**PLANNING DEPARTMENT ADMINISTRATIVE PUBLIC HEARING
SUMMIT COUNTY, UTAH
June 20, 2024**

- 1.A. **2466 Meadows Drive - Administrative Conditional Use Permit** - The Applicant Requests Approval for a Retaining Wall Constructed Greater Than Six Feet in the Front Setback. PL-23-05972
(A) Public Hearing; (B) Action

Subject: 2466 Meadows Drive
Application: PL-23-05972
Author: Lillian Zollinger, Planner II
Date: June 20, 2024
Type of Item: Administrative Conditional Use Permit

RE: RETAINING WALL CONSTRUCTION AT 2466 MEADOWS DRIVE, PARK CITY

Building Permit 20-775, Approved retaining wall heights (above).

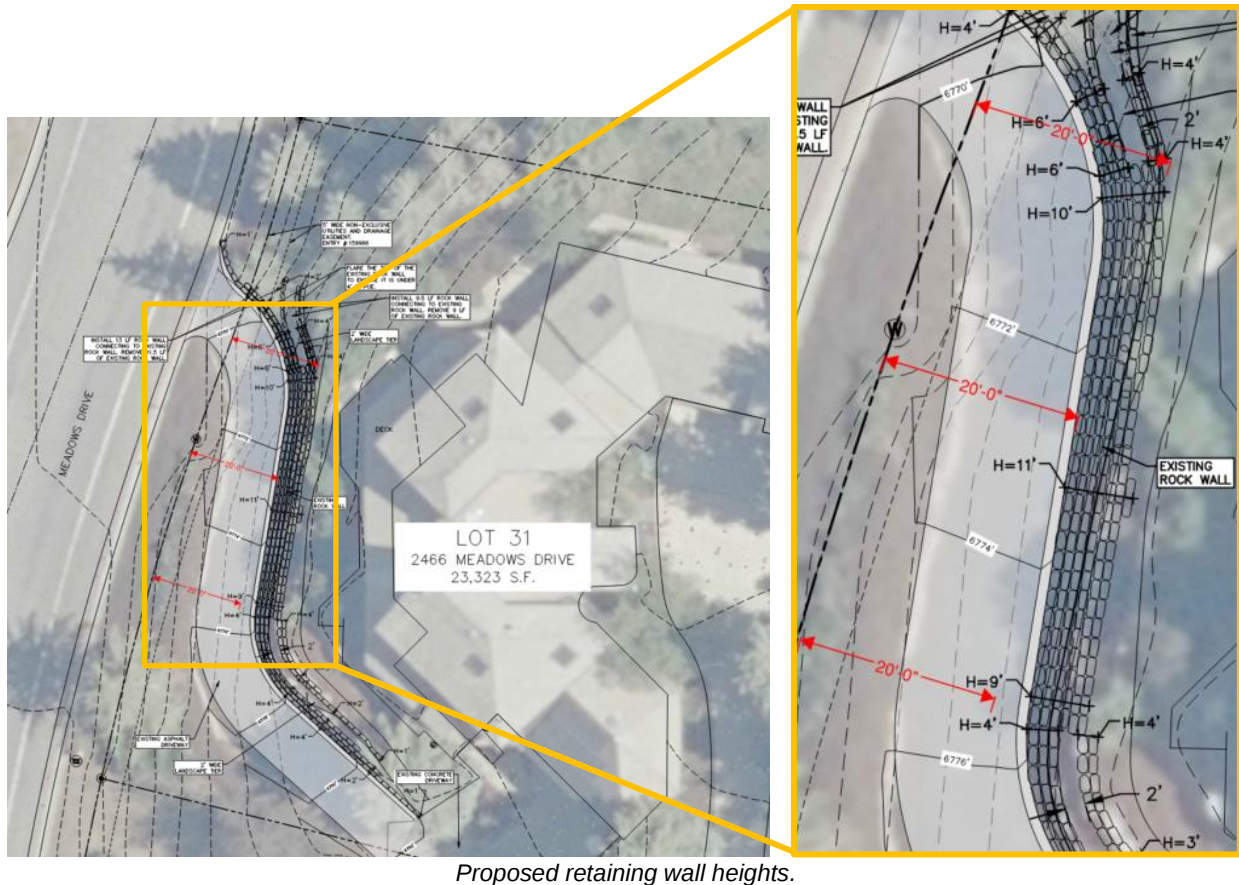
The retaining wall constructed in violation of Building Permit 20-775 exceeds the approved six feet height exception, in the Front Setback, ranging from two feet to 11 feet in height from Final Grade. LMC [§ 15-4-2\(A\)\(1\)](#) requires an Administrative Conditional Use Permit for retaining walls that exceed six feet in height from Final Grade in the Front Setback.
